**CRAWFORD APARTMENTS**

**EXTERIOR LIGHTING PLAN**

COUNTY FILE NUMBER: PPR2257

PLAN - EXTERIOR LIGHTING  
 SCALE: 1"=20'

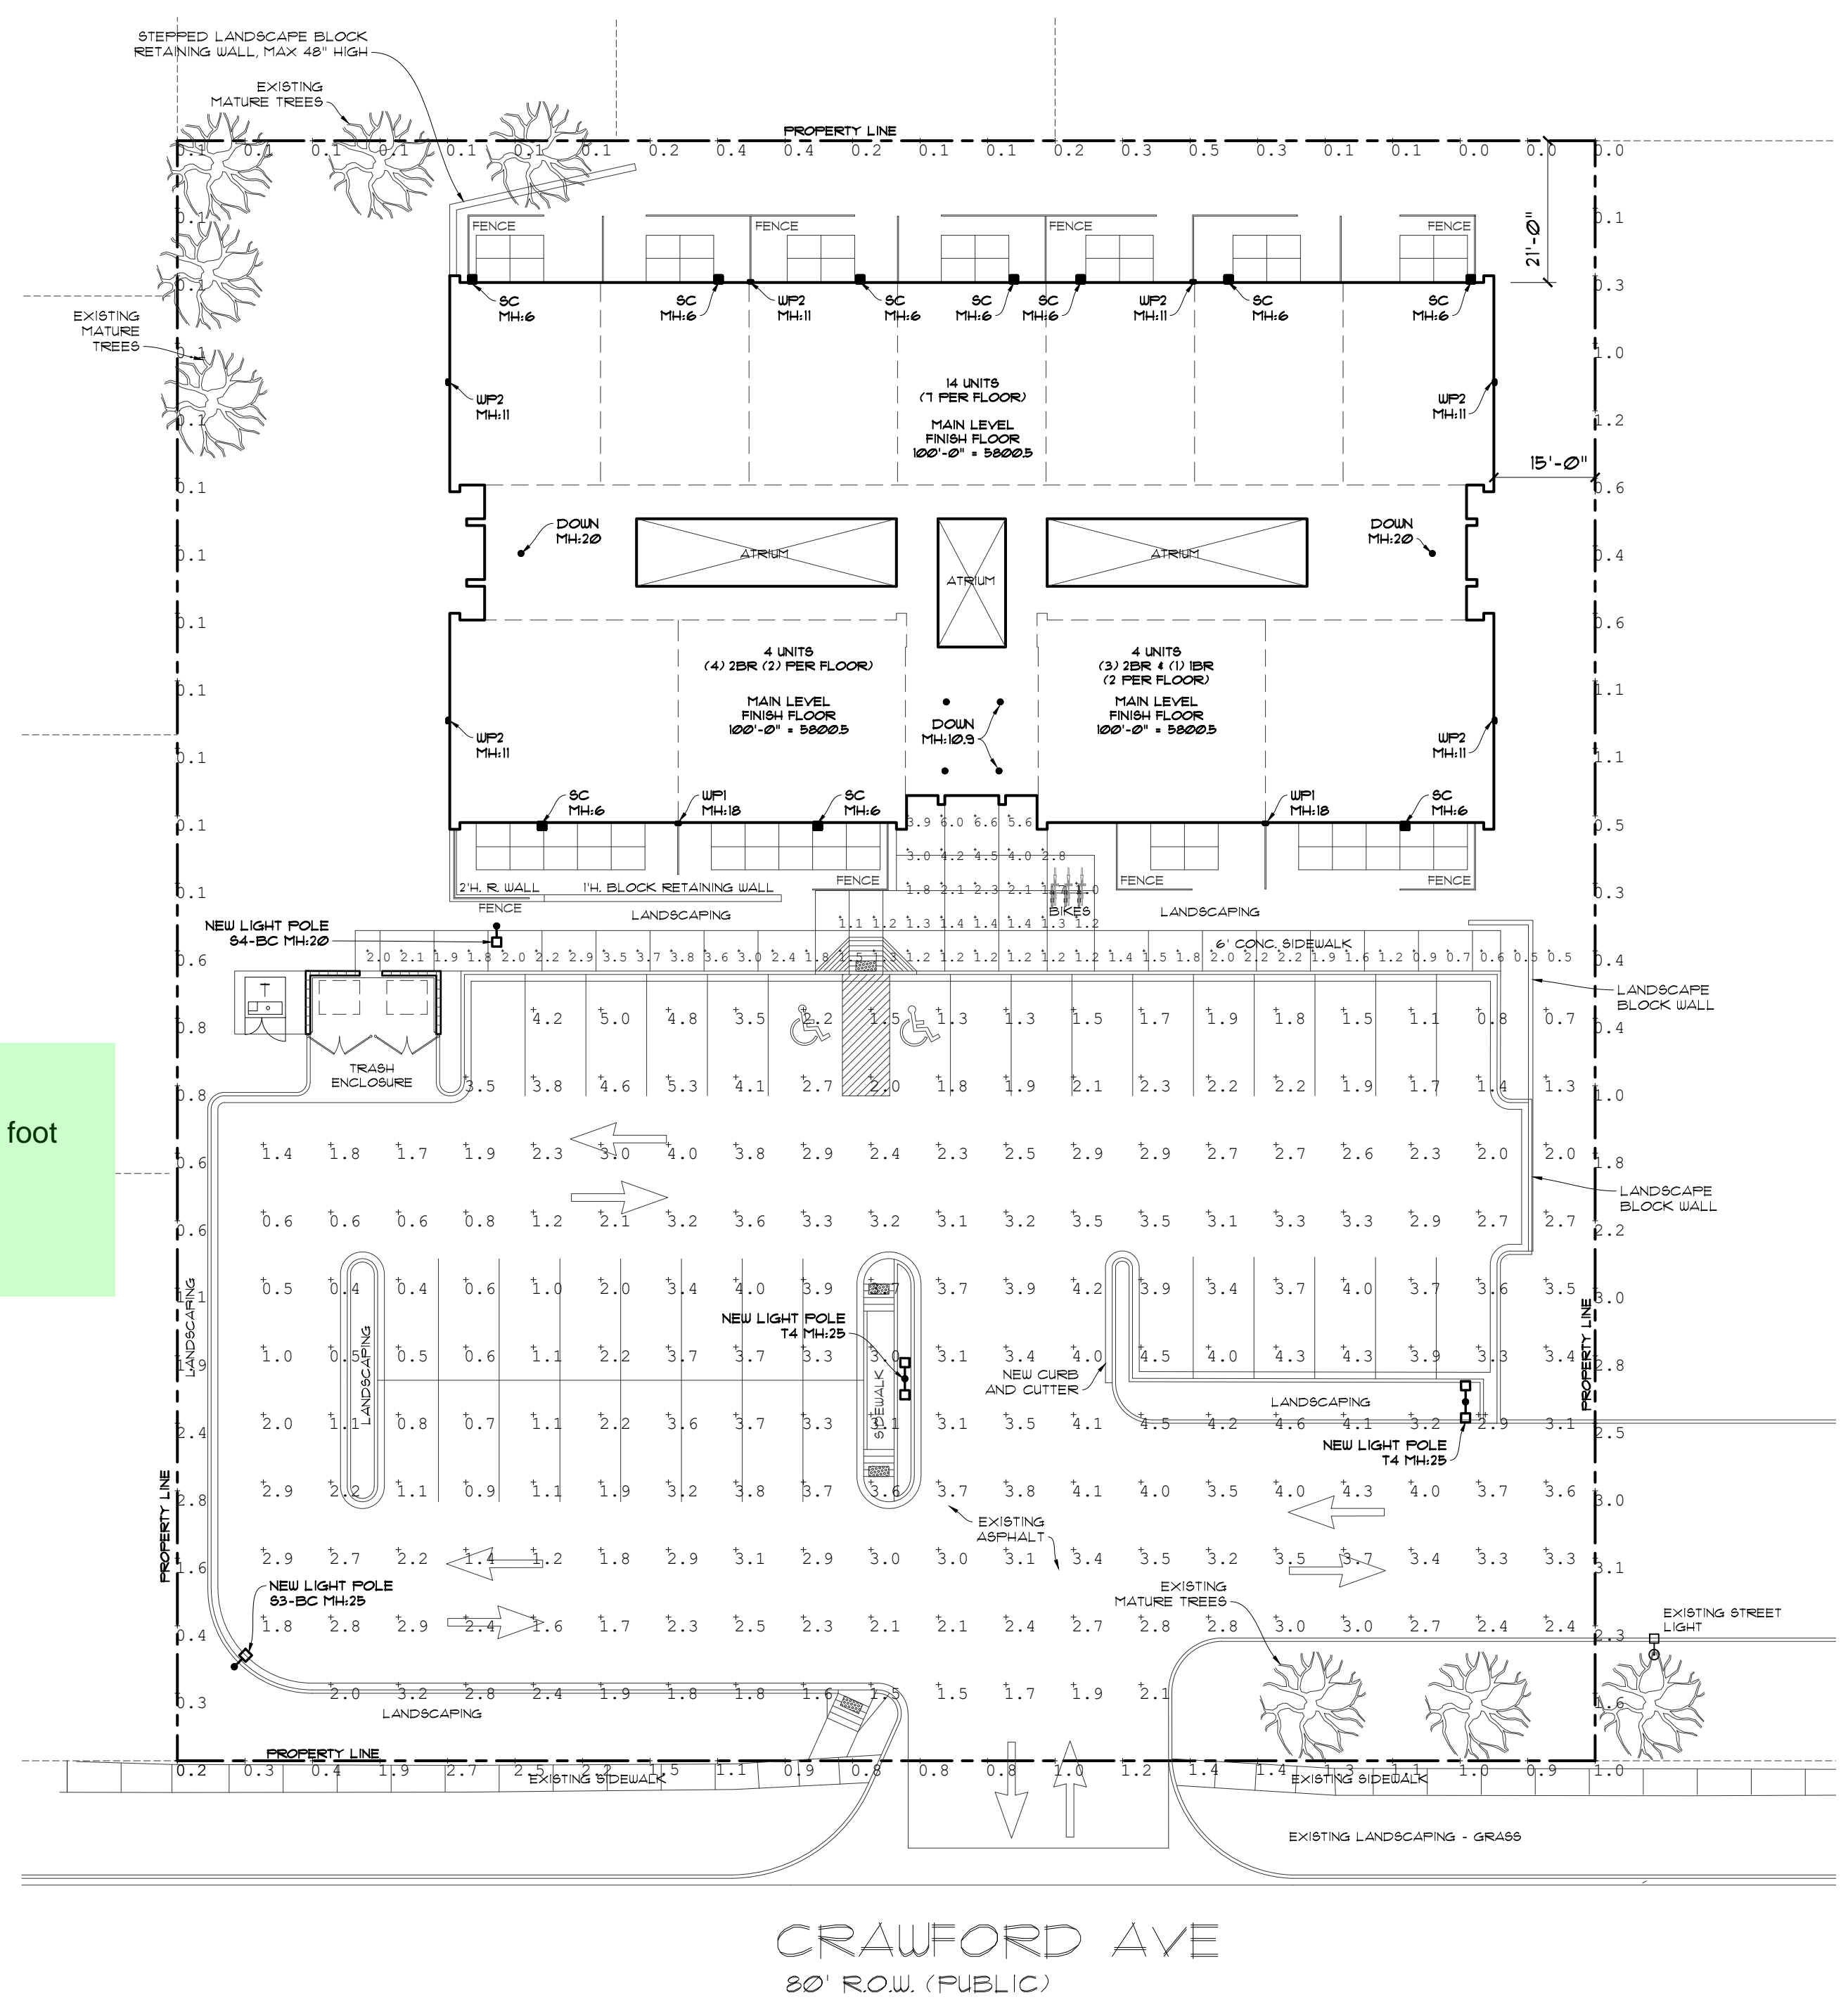
**UNRESOLVED V1 COMMENT:**  
 Lighting levels near a ROW or residential neighboring property must not exceed 0.1 foot candle levels, please adjust.  
 Section 6.2.3.B.1.e
